Proposed Revisions to a Standard Plans Index

Index Number: 430-001

Index Title: Miscellaneous Drainage Details

LIMITS OF VARIABLE FRONT SLOPES AT DRAINAGE STRUCTURES

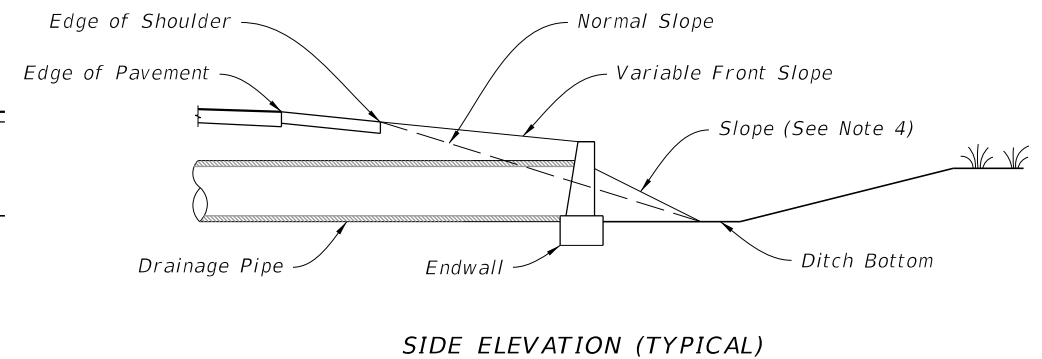
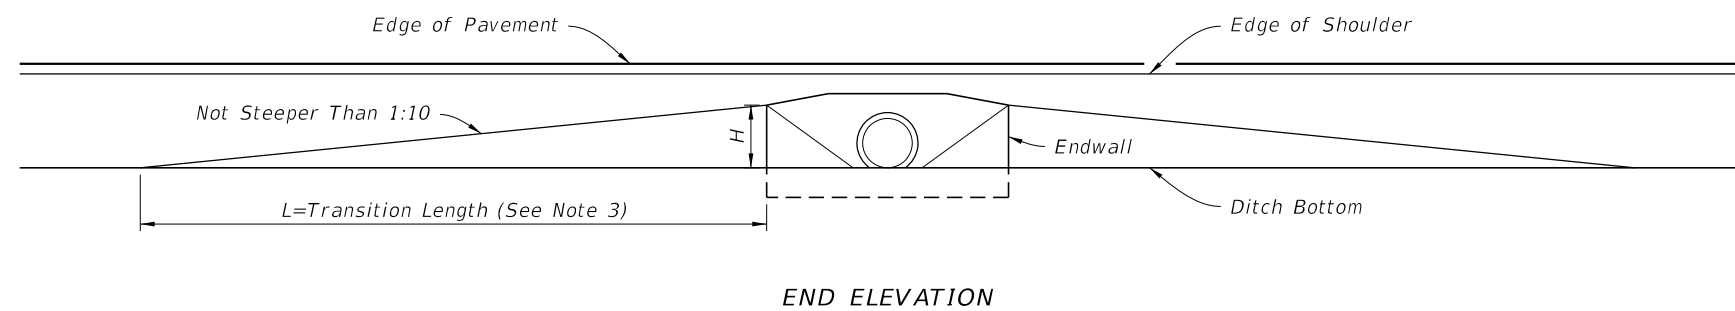
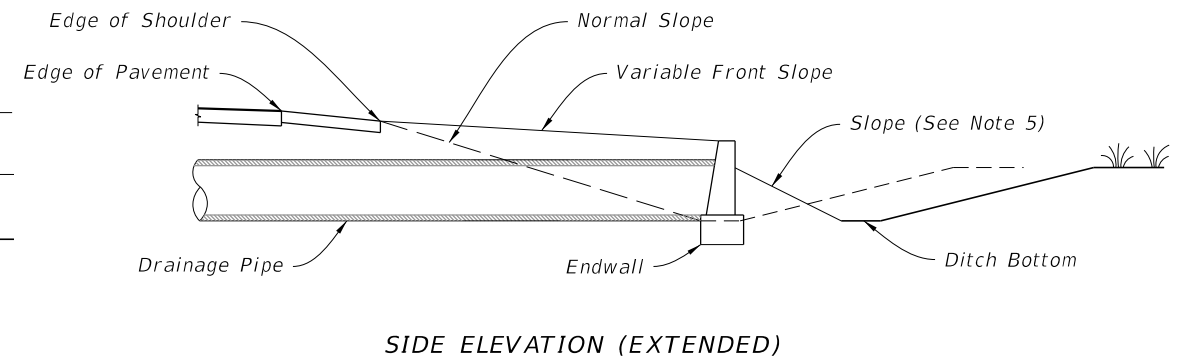
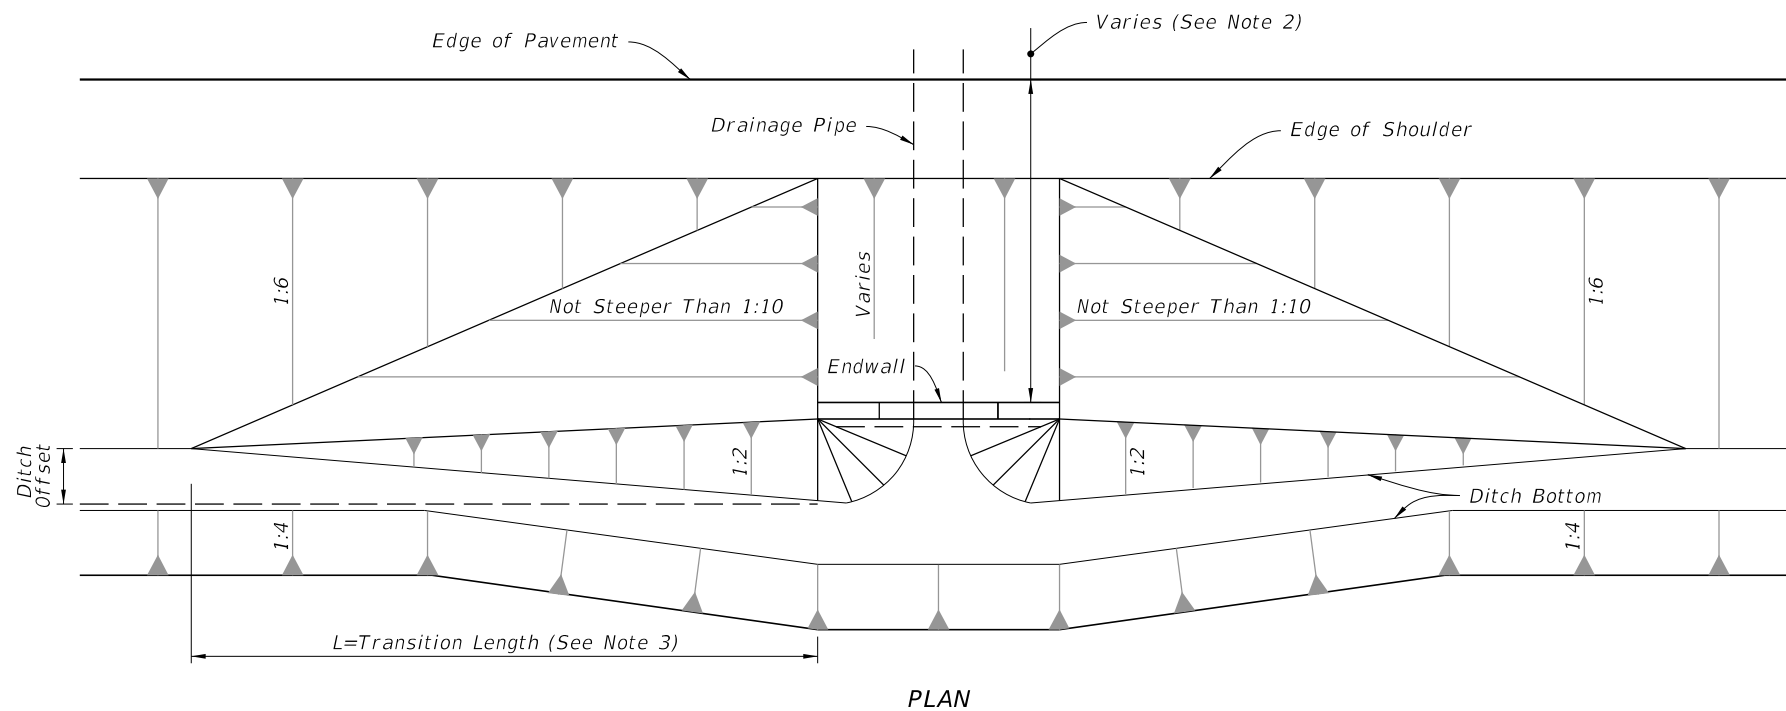
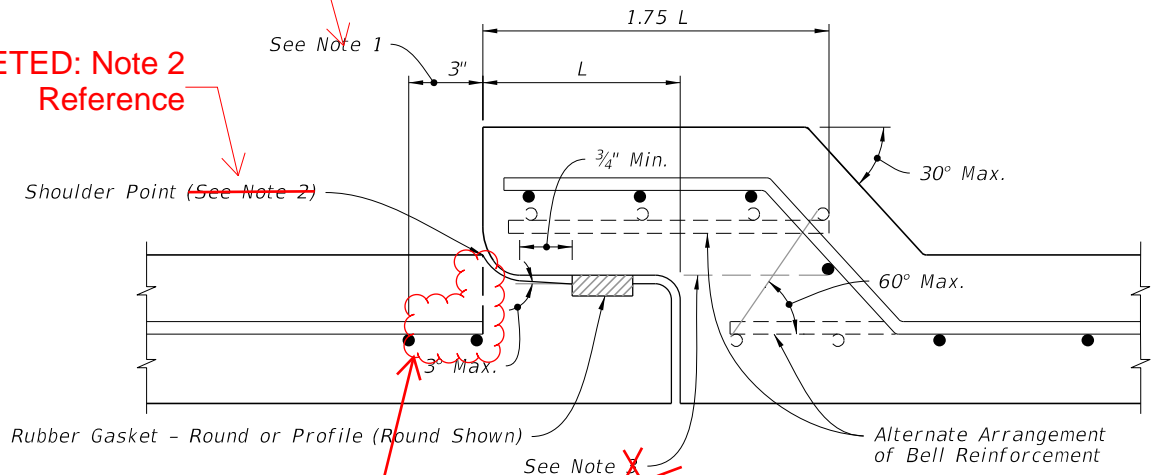
Sheet 1: Updated Table of Contents to reflect title change on Sheet 3.

UPDATED TITLE: Geotextile

ROUND AND ELLIPTICAL CONCRETE PIPE JOINT

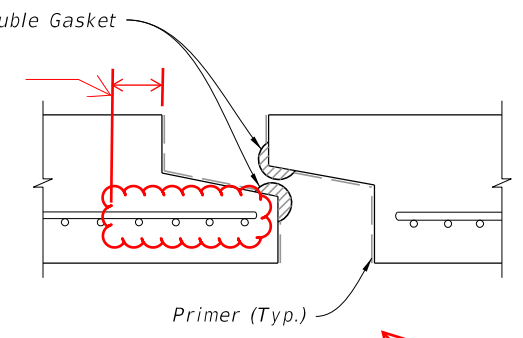
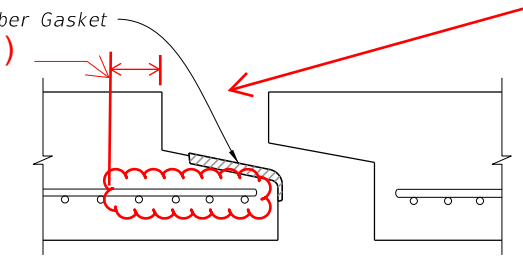
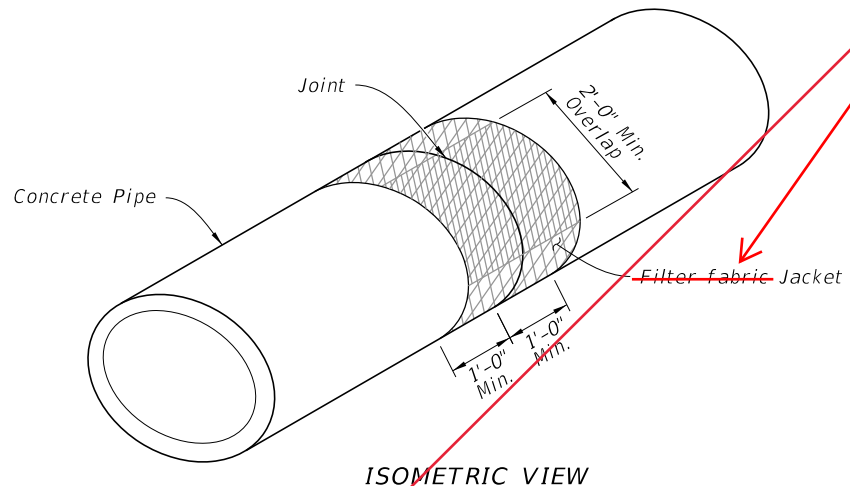
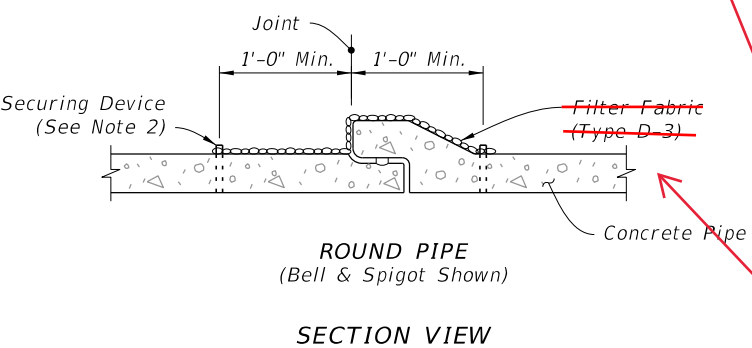
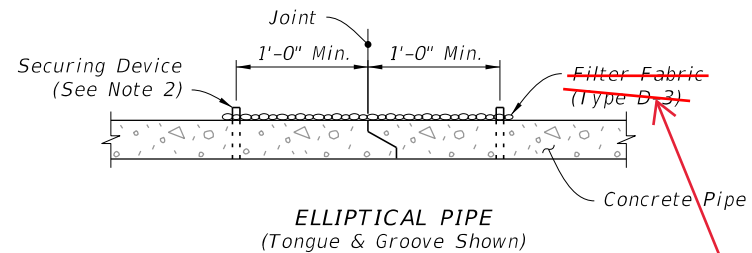
Deleted Notes 1 and 2 on Round Concrete Pipe Joint Detail; Added new Note 1 "Allowable tolerance for the last full wrap of circumferential reinforcement shall be within 3 inches from the spigot shoulder and meet ASTM C76 for round pipe or ASTM C507 for elliptical pipe."; renumbered notes on Elliptical Concrete Pipe Joint Detail; Updated Note 3 on Elliptical Concrete Pipe Joint Detail; Updated Profile Rubber Gasket and Preformed Plastic Joint to show 3" dimension and added Note 1 reference; deleted rebar to 3" dimension on all details; deleted Note 2 reference and changed "See Note 3" callout to "See Note 2" on Round Concrete Pipe Joint Detail

3" Max (See Note 1)

DELETED: Note 2 Reference

UPDATED DETAILS:
To show 3" dimension;
added Note 1 reference;
deleted rebar to 3" dimension

ADDED: New Note 1
Locate the last full wrap of reinforcement within 3 inches of the spigot shoulder and meet ASTM C507 for elliptical pipe.

NOTES:
~~1. Allowable Tolerance for the last full wrap of reinforcing when using single elliptical cage.~~
~~2. Extend the last full wrap of reinforcing to the shoulder point and meet ASTM C 76 requirements.~~
 2. All circumferential steel located above this line and within the 1.75 L is defined as bell reinforcement.

Deleted Note 1 and 2

UPDATED: "Joint is homed."

ADDED: New Note 1
Locate the last full wrap of reinforcement within 3 inches of the spigot shoulder and meet ASTM C76 for round pipe.

A search in ASTM archives shows that the "within 3 inches of spigot shoulder" language has existed since about 1985 in both C76 and C507. Our standard Plans were updated in 2004 which moved the last wrap from inside the joint to the shoulder, but it is unknown why the 3" guidance was omitted. This change brings the Standard Plans in line with the ASTM specifications.

FILTER FABRIC JACKET, CONCRETE JACKET, AND PIPE PLUG

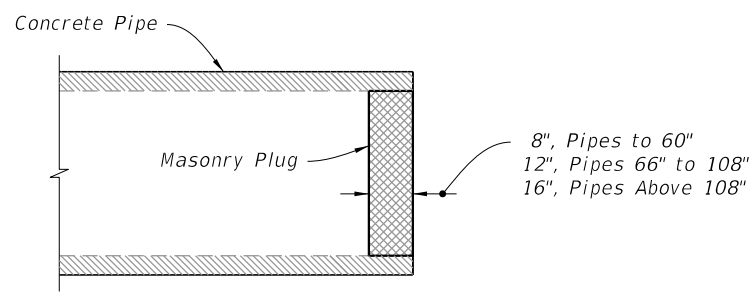
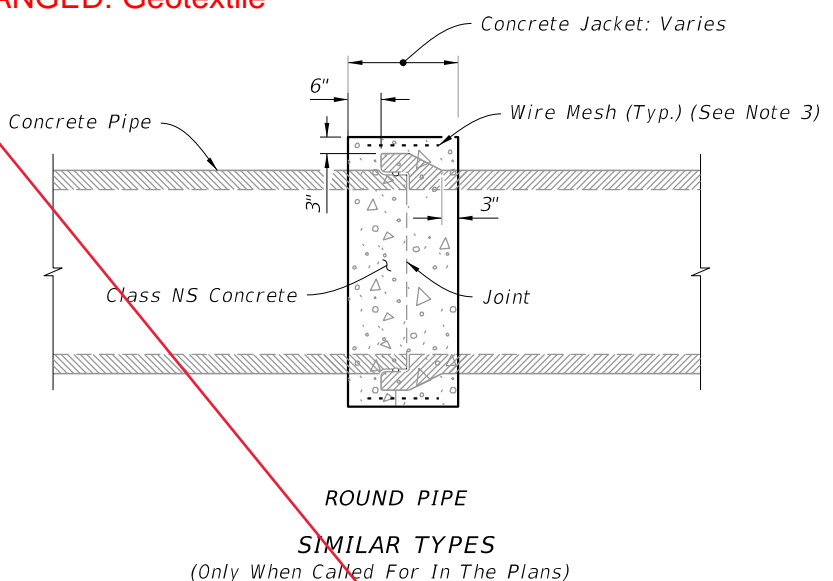
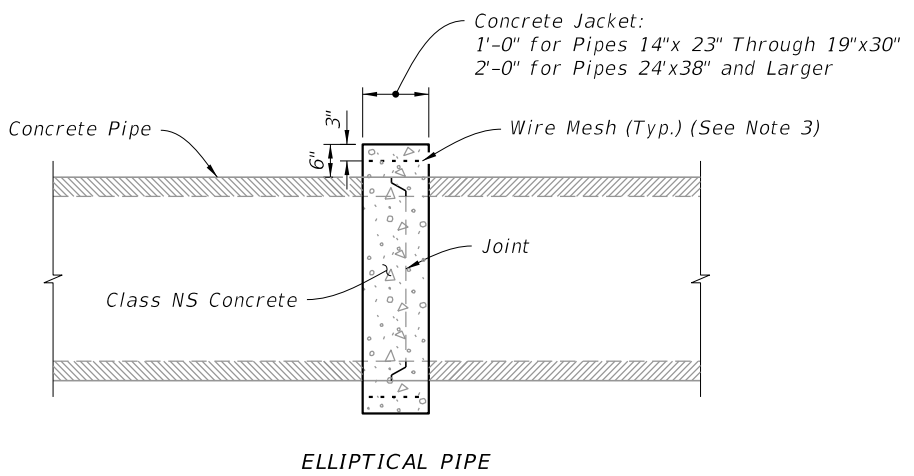
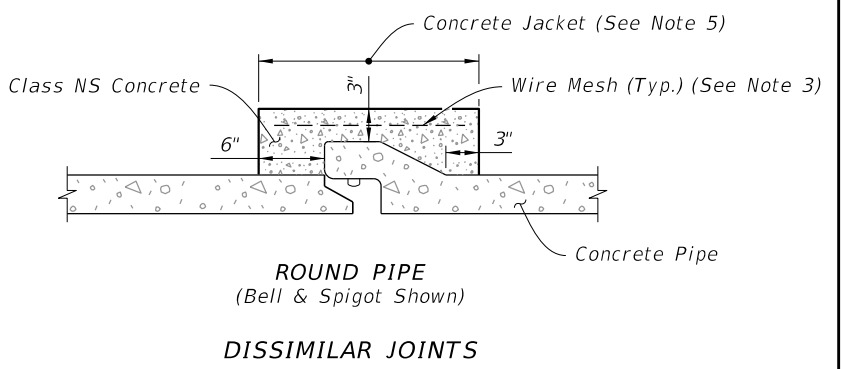
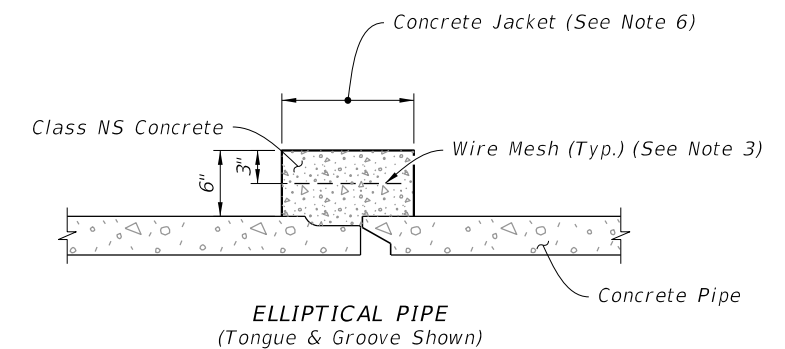
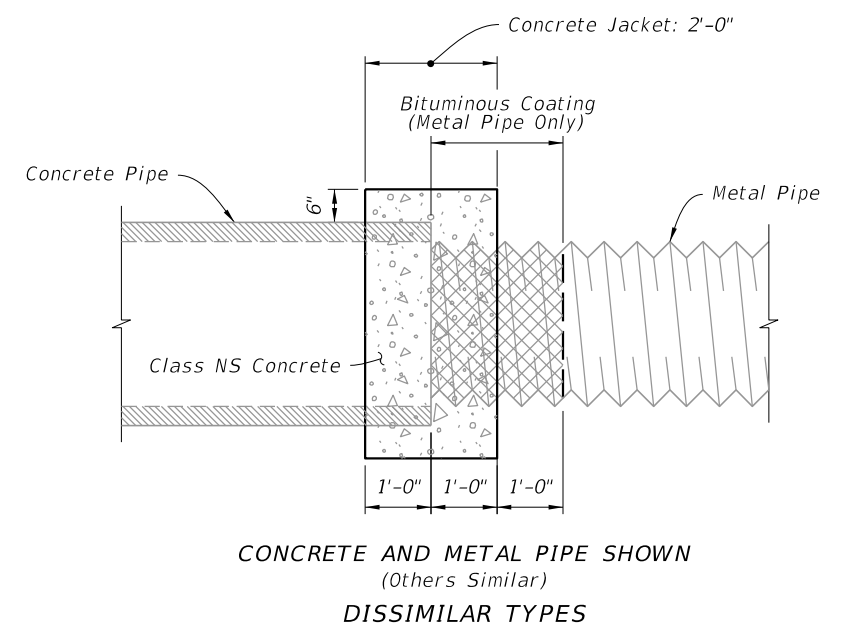
Sheet 3: Updated Note 2 "Install Type D-3 geotextile in accordance with Specification 514. Install securing device to hold the geotextile jacket on to the pipe." ; Changed all references of "Filter Fabric" to "Geotextile".

UPDATED: Note 2
Type D-3 Geotextile

CHANGED: Geotextile

UPDATED Note 2: Install Type D-3 geotextile in accordance with Specification 514. Install securing device to hold the geotextile jacket on to the pipe.

In the July 2022 SSRBC workbook, construction requirements for the Contractor for geosynthetic materials from Section 985 was removed. The reason for it was that the construction requirements doesn't belong in Division III of the specifications, as this is for producer requirements. Instead of applying specific requirements to each individual specs that references 985 in Division II, the Department is going to modify specification 514 to cover geosynthetics used for drainage applications. Specs 145 covers the reinforcement (structural) applications and construction requirements and erosion control has specific requirements in various areas of Division II, therefore, both erosion and reinforcement are covered. The only missing link in Division II is the drainage applications. Proposed changes to 514 cover construction requirements and material acceptance. In addition, specs 514 ensures that the Contractor obtains geosynthetic product from a manufacturer that meets 985 spec requirements.

ROUND AND ELLIPTICAL CONCRETE PIPE JOINT

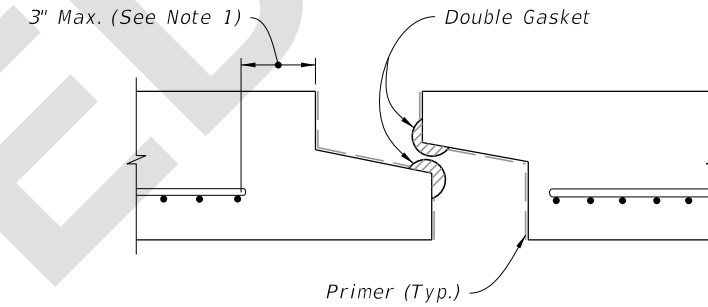
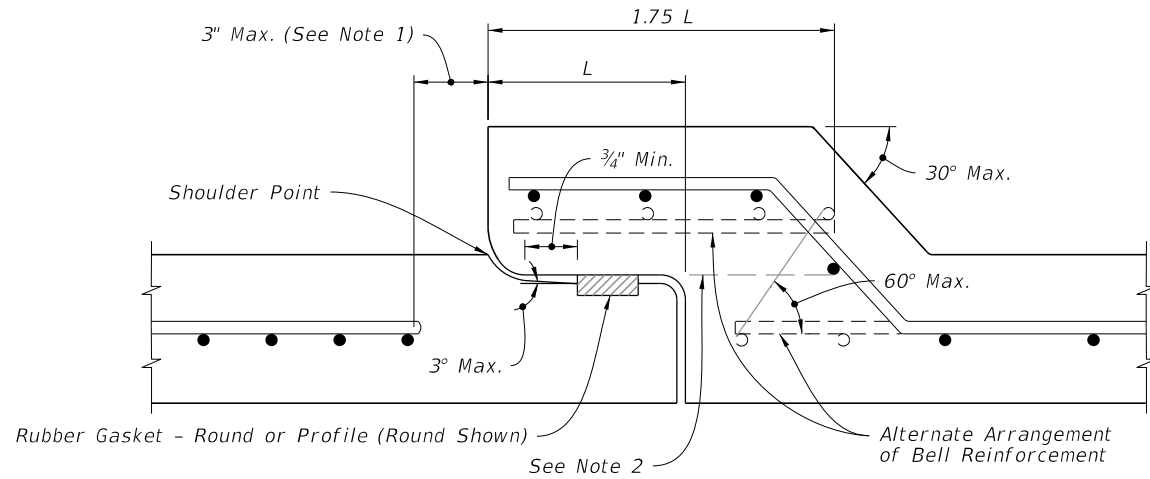
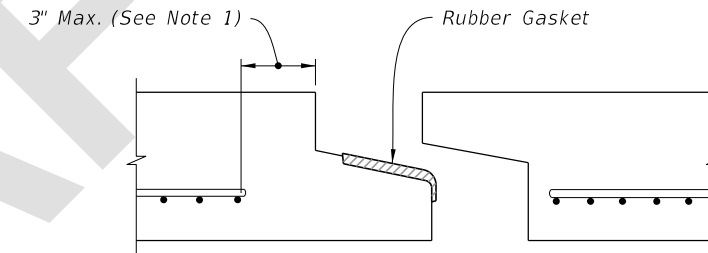
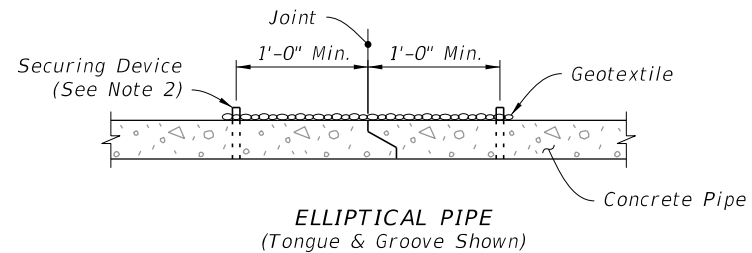
1. Locate the last full wrap of reinforcement within 3 inches of the spigot shoulder and meet ASTM C76 for round pipe.
2. All circumferential steel located above this line and within the 1.75 L is defined as bell reinforcement.

1. Locate the last full wrap of reinforcement within 3 inches of the spigot shoulder and meet ASTM C507 for elliptical pipe.
2. Type D-3 Geotextile Jacket is required on both type of joints.
3. Details shown before joint is homed.

GEOTEXTILE JACKET, CONCRETE JACKET, AND PIPE PLUG

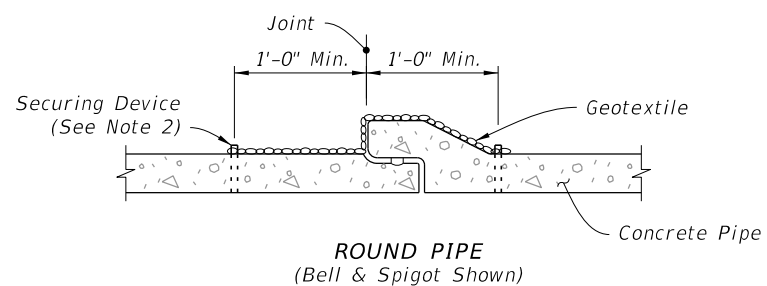
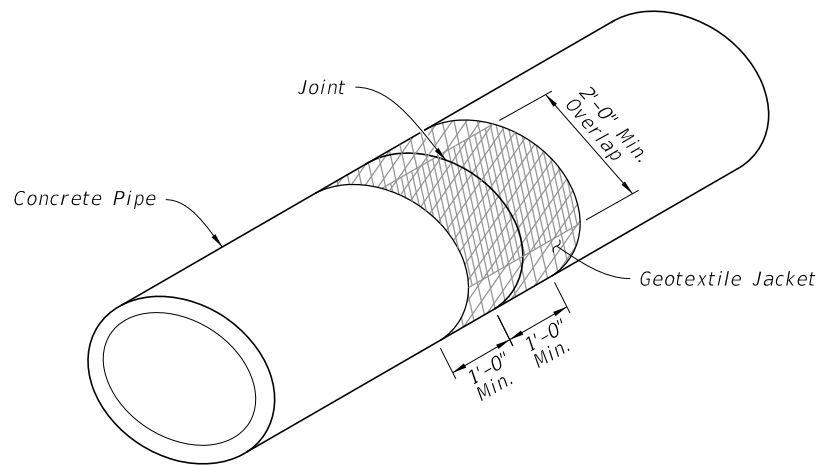
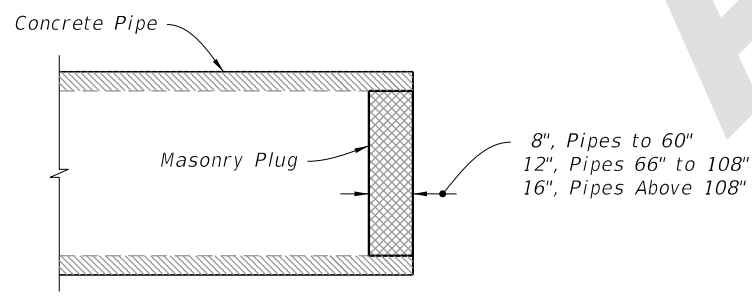
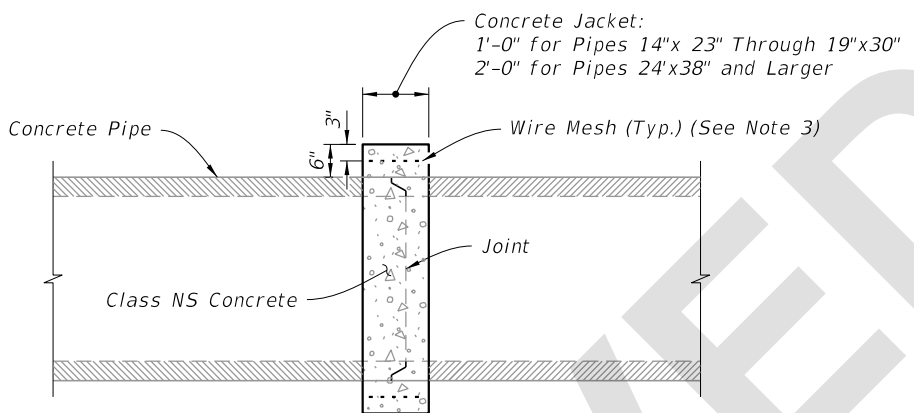
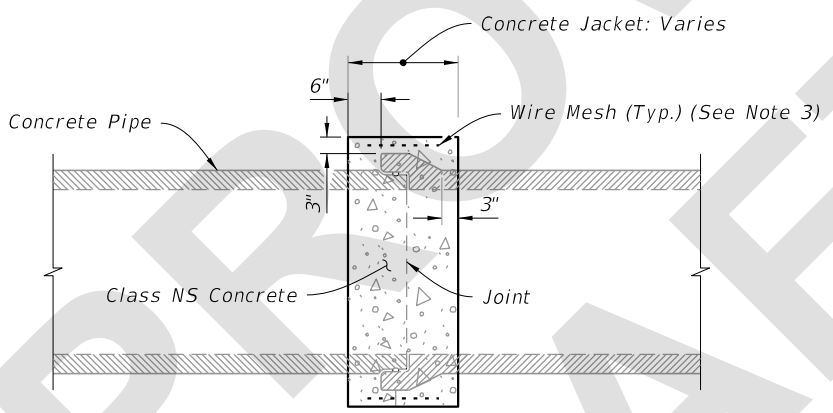
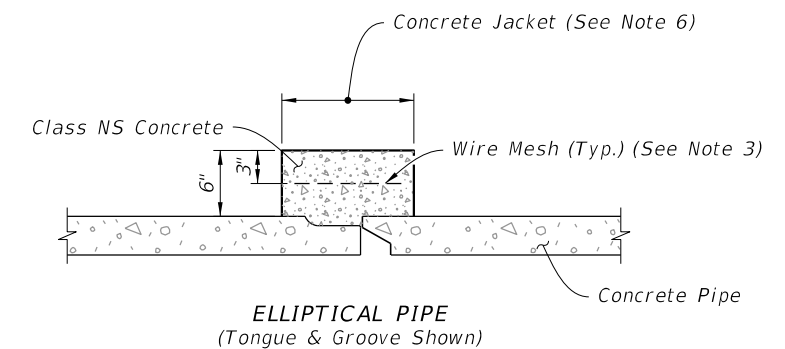
1. Alternate connection must be approved by the Engineer.
2. Install Type D-3 geotextile in accordance with Specification 514. Install securing device to hold the geotextile jacket on to the pipe.
3. Any wire mesh arrangement which provides 0.126 square inches of steel area per linear foot both ways may be used, provided the wires are spaced a minimum of 2" and/or a maximum of 6" on centers.
4. Do not use a concrete jacket to join dissimilar metal pipes.
5. 12" for pipes 15" through 24"; 24" for pipes 30" and larger.
6. 12" for pipes 14" x 23" through 19" x 30"; 24" for pipes 24" x 38" and larger.
